ACCESS AUDIT REPORT

NATIONAL MUSEUM

13th November 2009

- Access audit report is prepared by the Access Resource Group of SAMARTHYAM following familiarization; preliminary survey, detailed Access Audit of National Museum conducted on 13th November 2009.
- The aim of this report is to highlight access initiatives undertaken in the preliminary surveys, along with recommendations for areas which need immediate attention i.e. existing barriers in the periphery of the complex and to illustrate ways of making it more accessible.
- The report attempts to cover the access needs of visitors and employees with reduced mobility including the elderly, pregnant women, persons with temporary impairments and persons with disabilities.
- The recommendations of the access audit are based on ground realities and provide cost effective solutions.
- A list of companies/vendors supplying accessible accessories is also given in the report.

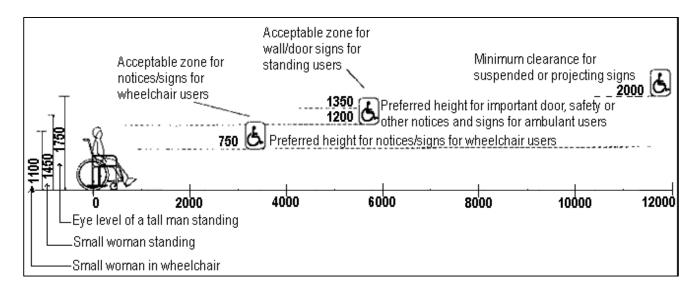
Orientation for persons with vision impairment has not been provided.

- ♣ Tactile Guiding tiles (refer Annexure IV for engineering configuration) are proposed for persons with low vision and vision impairment.
- The guiding path should lead to important amenities/facilities such as ramps to building entrances and clearly avoid vehicle movement areas. This benefits everyone including persons with disabilities.

a) Font and size of letters

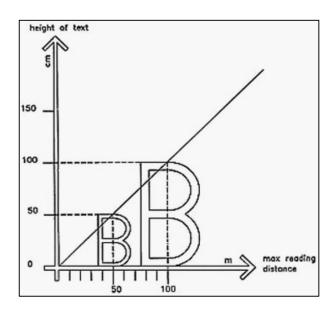
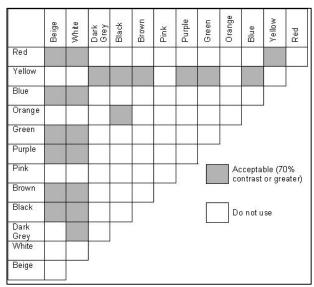
Directional information signage has not been provided.

The size of letters shall be selected in accordance with viewing distance, taking account of the diminished eyesight of the aged.

- Be clear with Sans serif typeface
- Be in lower and upper case and left justified
- Embossed with Braille and Braille locators- individual characters between 15mm-50mm tall, raised by 1-1.5mm
- Non glare colour contrasted with their background
- Font sizes
- Medium range signs characters 70 100mm high
- Close up directories characters 15 25mm high
- Signage Colour and Contrast Basic principles:
- 70% contrast between wall and sign panel
- Avoid shades of colours
- Avoid using same colours as safety signs

ENTRANCE

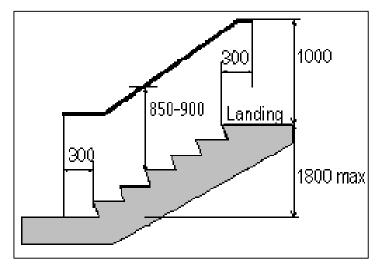
Main entrance has a flight of steps.

Handrail height and diameter are not as per standards.

Handrails also do not extend beyond the first step making it difficult for persons using mobility aids such as sticks and crutches, who prefer to use steps.

- Handrails on both the sides and middle of the steps to be provided, at two levels, for balance and support for persons with reduced mobility.
- Refer Annexure III for handrail height and diameter standards.
- Handrails to extend by at least 300mm beyond the head and foot of the flight in the line of travel and grouted in the ground (refer illustration).

Existing lift call buttons and control panel

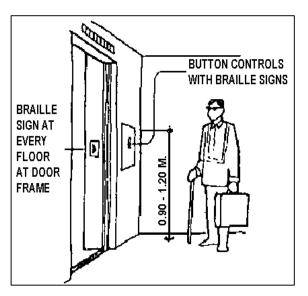
Call buttons are placed out of reach of persons seated in wheelchair.

Call and control panels buttons do not have Braille markings for persons with vision impairment.

- Call button should be placed at a reach of 900mm-1000mm; at least 400mm from any corner or have a clear floor space of at least 900 mm x 1200 mm with no obstruction placed to prevent a wheelchair user from reaching the call button.
- Lift signage with Braille markings (as illustrated) should be provided at strategic location.
- Floor signages to be also provided facing the lift for easy identification.
